## SAFETY RELATED RECALL

Global Recall Action  
Number: D113v1

| Subject:<br><b>Defender 110 Third Row Seatbelt Mounting Bracket - Incorrect Specification</b> | Publication No.: D113v1      |

# SERVICE INSTRUCTION - D113V1

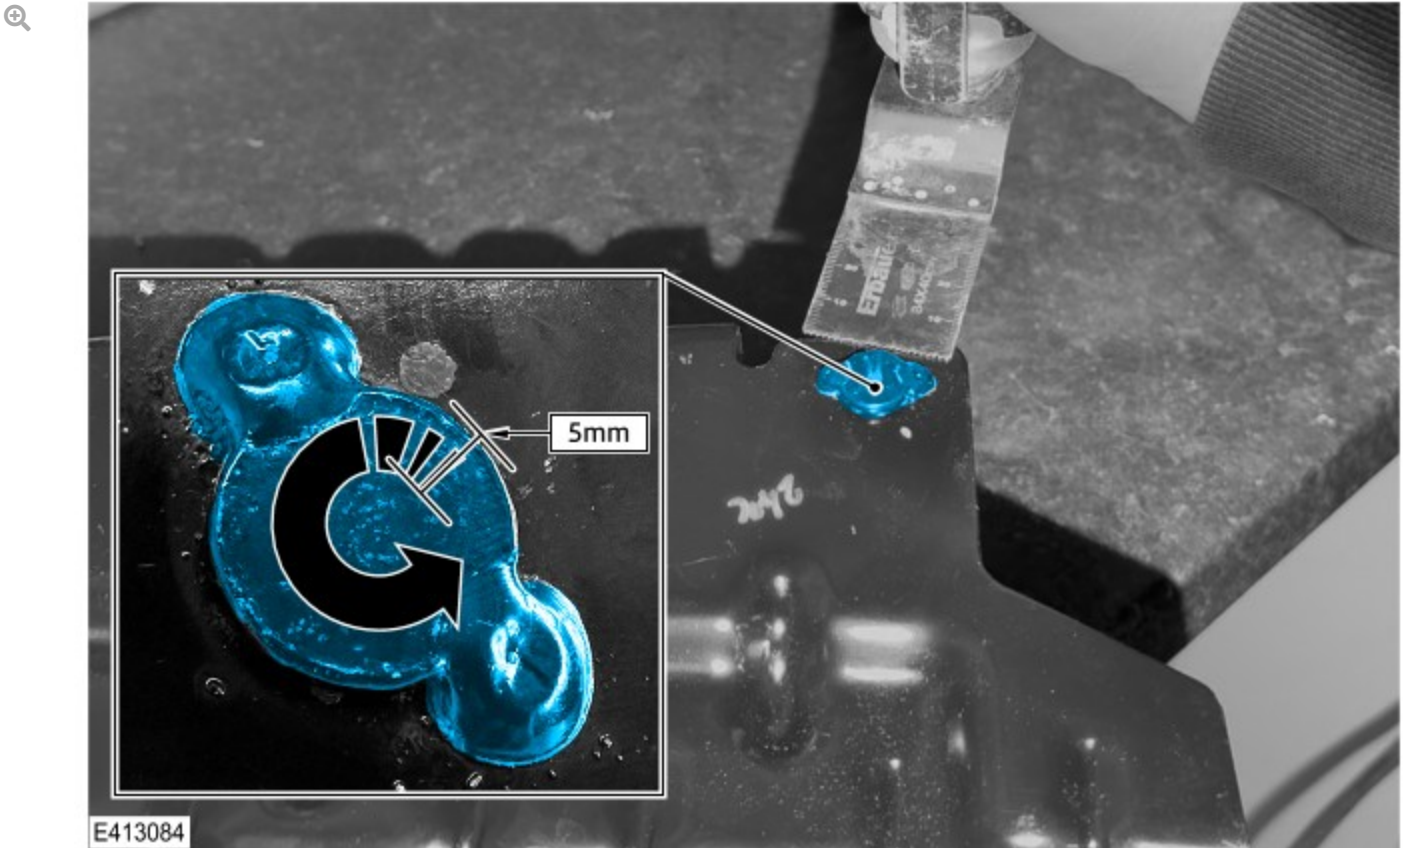
- Cut through the 2 welds securing the stud to the third row seatbelt anchor bracket.
- Cut a minimum of a 5 mm deep groove below the stud head and around the entire circumference of the stud.

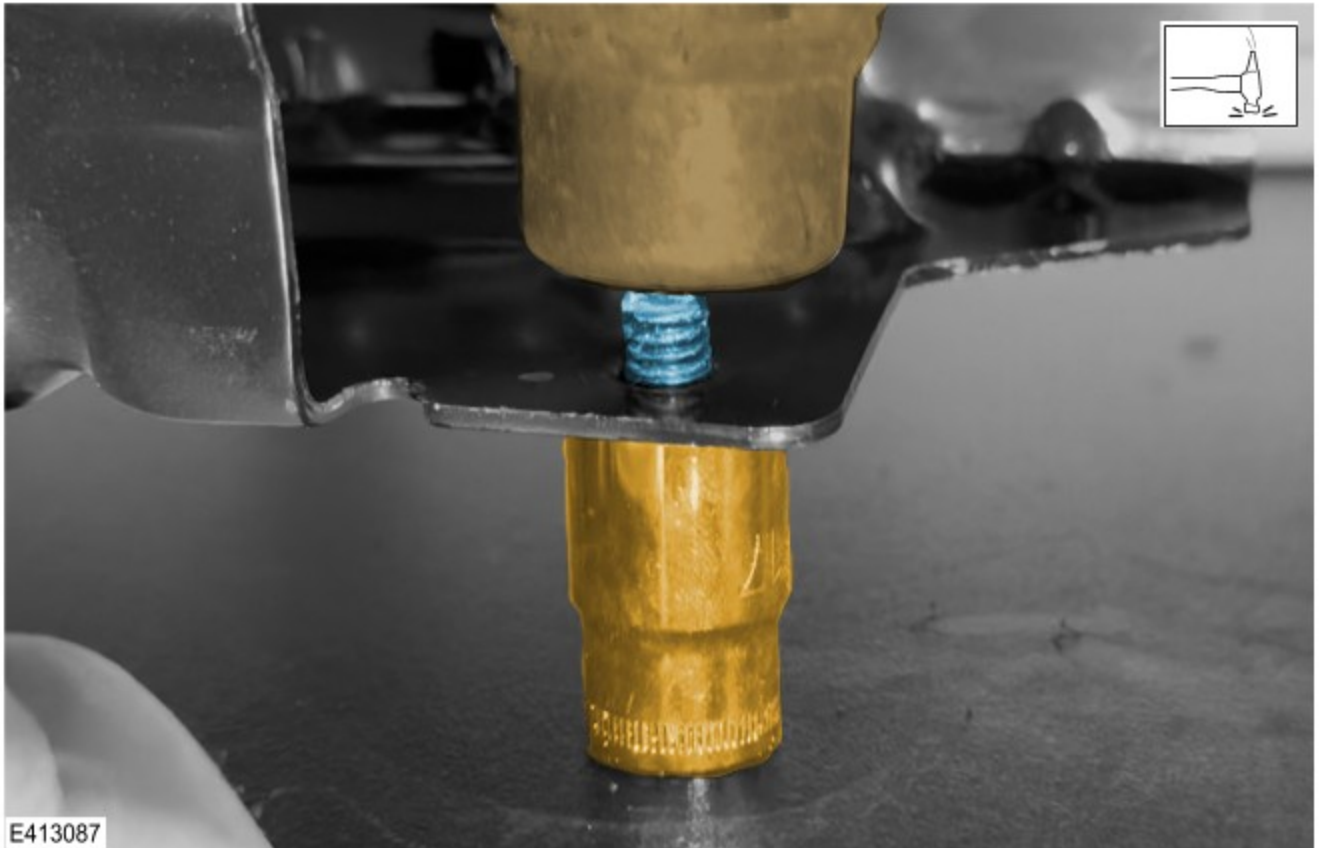
- Remove the third row seatbelt anchor bracket from the vice.
- Rest the bracket on a suitable size socket, or similar tool, with the thread of the stud pointing upwards, as shown in the illustration.
- Using a suitable hammer and punch, hammer the stud out of the third row seatbelt anchor bracket.
- The third row seatbelt anchor bracket must be straight, without deformities, before continuing.

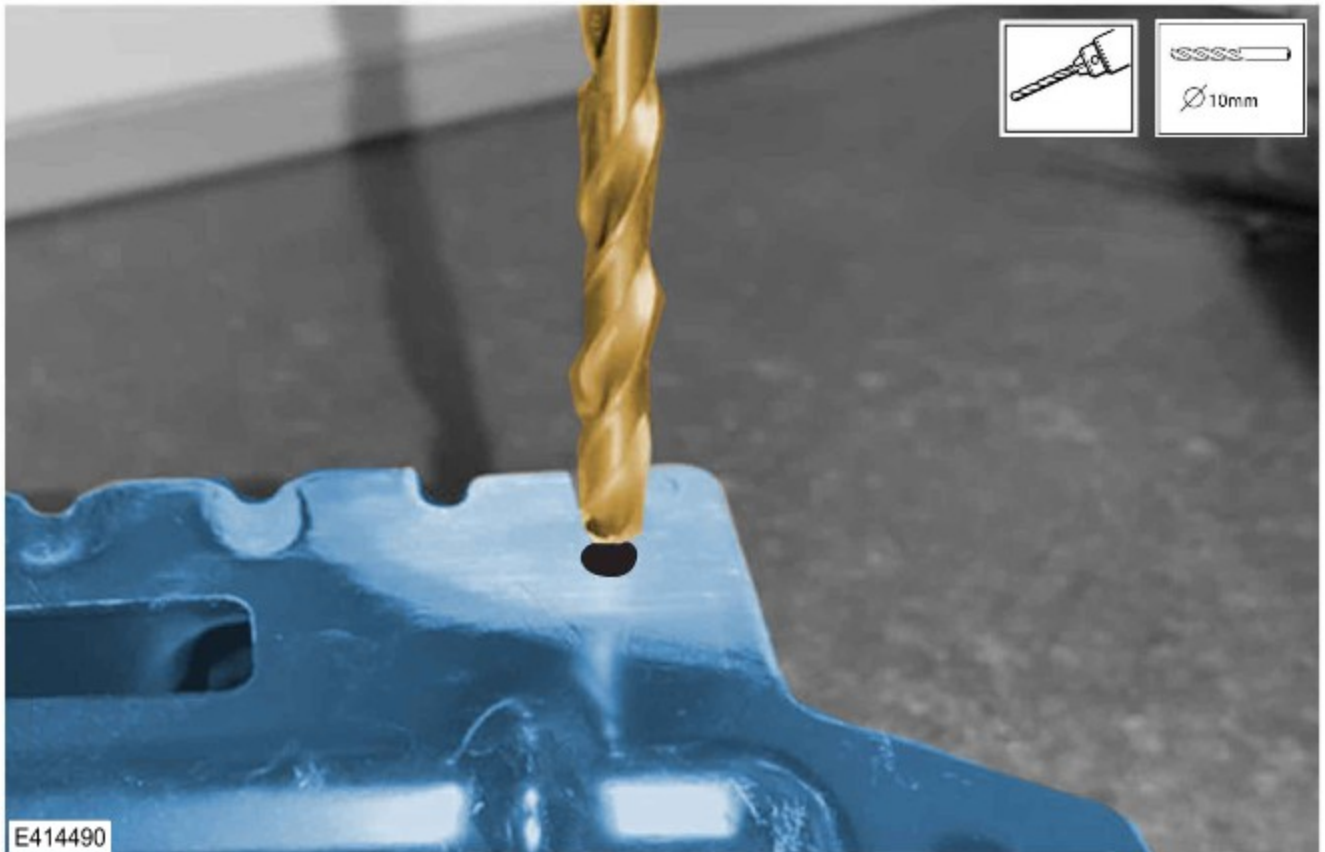
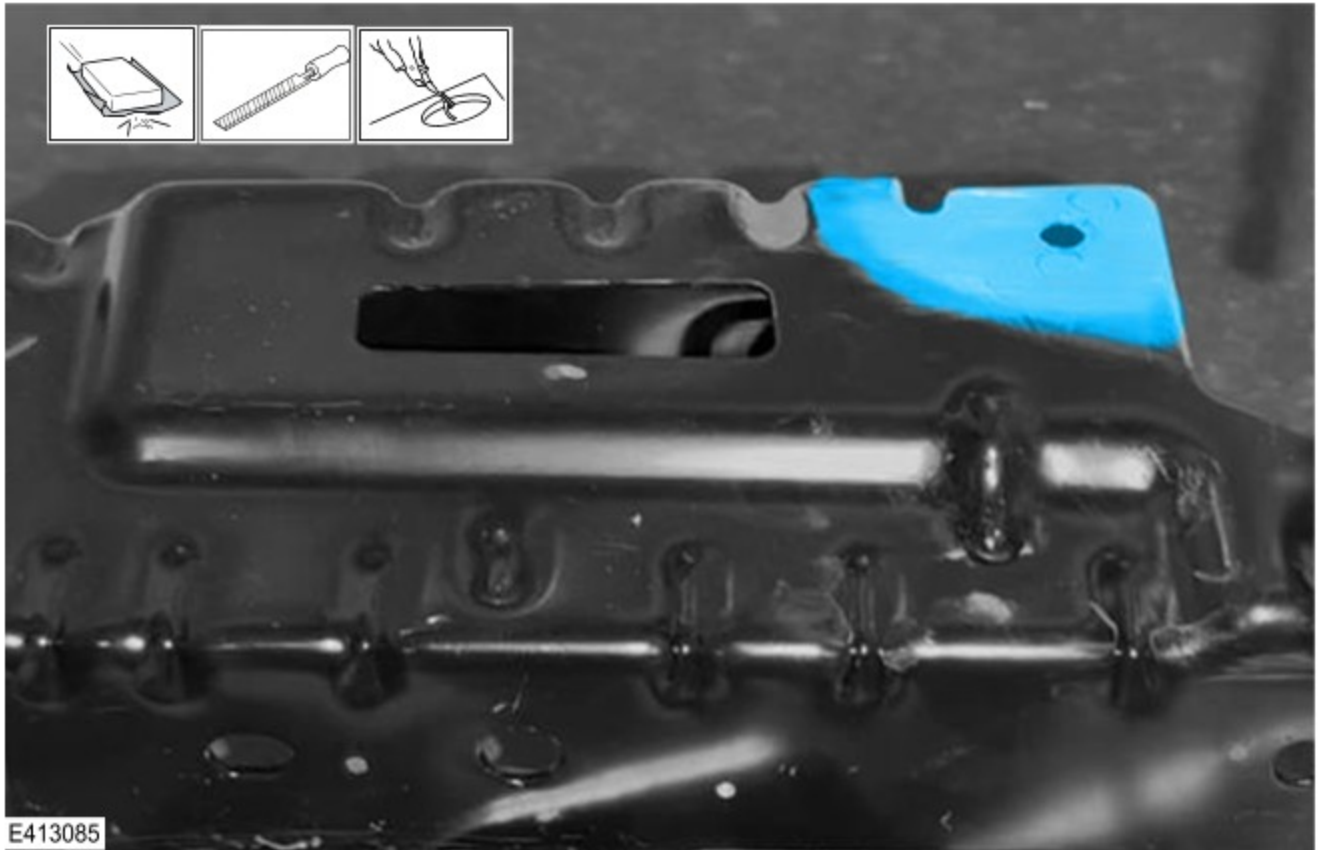
The drill must be upright and central at all times.

Run a 10 mm drill bit through the third row seatbelt anchor bracket hole.

| <b>Important:</b>            | <p>Rest of World: Quarantine in JLR retailer / authorized repairer or applicable NSC location.</p> <p>NOTE: The information in this campaign is intended for use by professional technicians. If you are not a JLR retailer / authorized repairer, do not assume that a condition described affects a specific vehicle. Contact an authorized JLR retailer / authorized repairer to determine if this campaign applies to a specific vehicle.</p> <p>This bulletin supersedes <a href="#">Update Prior to Sale (UPS)</a> UPS0926 with immediate effect. The blue highlighted text relates only to the date information. All text in this bulletin should be read and understood in full.</p> <p><b>The D113 Safety Recall has been updated to highlight the requirement for photographic evidence to be attached to the warranty claim. Drill out requirement is now 10 mm. Check and adhere to the new repair instructions.</b></p> |

E414491

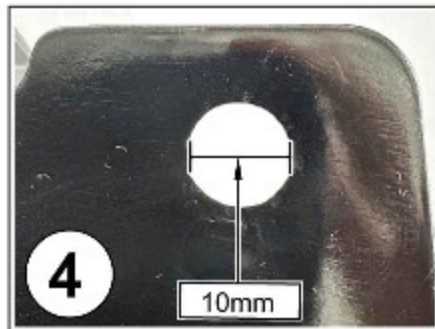
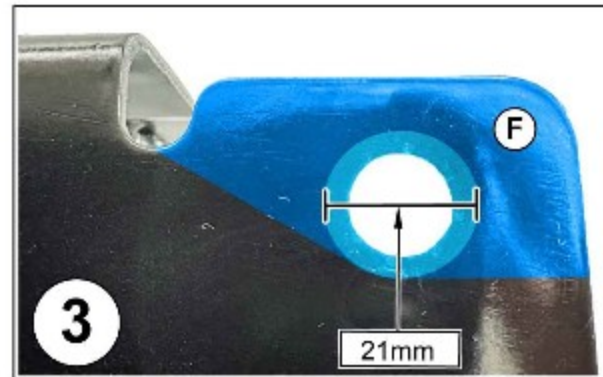
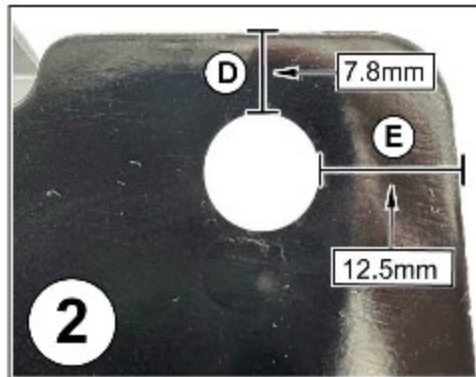
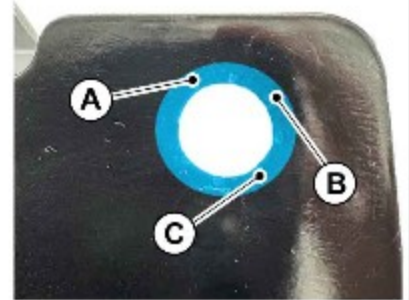
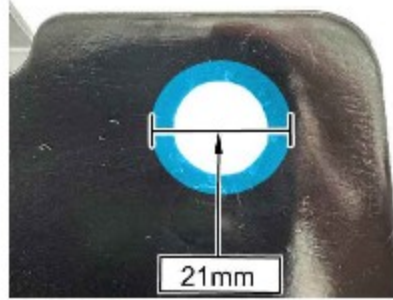
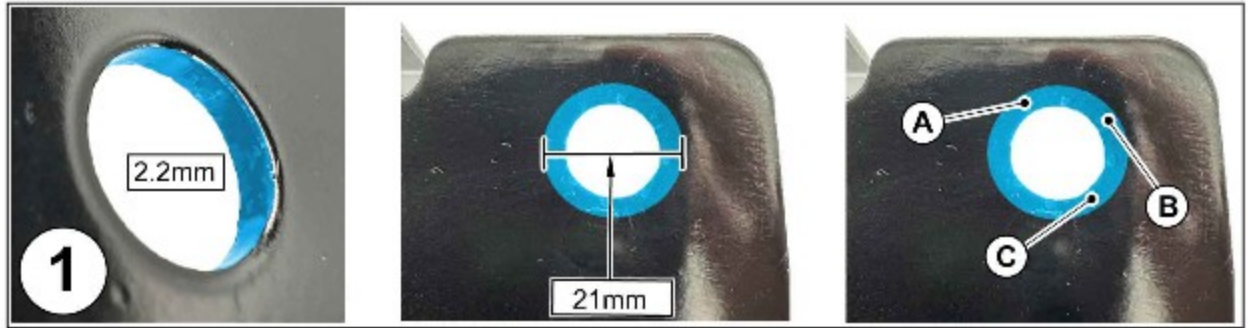
1. Using the images provided for reference, measure the thickness of the third row seatbelt anchor bracket. There must be a **minimum** thickness of 2.2 mm within the 21 mm perimeter around the drilled hole. Also, specifically measure the thickness of the areas marked A, B, and C. The deviation in thickness across points A, B, and C **MUST NOT** exceed 0.5 mm.

2. Measure from the edge of the drilled hole to the edge of the third row seatbelt anchor bracket, in the areas shown.
  - D) There **MUST** be a **minimum** of 7.8 mm from the edge of the drilled hole to the edge of the third row seatbelt anchor bracket, in the area shown.

- E) There **MUST** be a **minimum** of 12.5 mm from the edge of the drilled hole to the edge of the third row seatbelt anchor bracket, in the area shown.

3. Visually inspect the wider area of the third row seatbelt anchor bracket shown as Dark Blue in the illustration and marked F. Inspect for any incidental damage caused during steps 9 to 12. Any incidental damage present **MUST NOT** reduce the thickness of the third row seatbelt anchor bracket to less than 2.2 mm in the area shown.

4. Measure the diameter of the drilled hole. The diameter of the drilled hole **MUST** measure between 10 mm - 10.5 mm.

If **1 or more** of the below requirements cannot be achieved, a new third row seatbelt anchor bracket **MUST** be installed, continue to quarantine the vehicle and await a further communication. Do **NOT** install any third row seatbelt anchor bracket which does not meet **1 or more** of the below requirements.
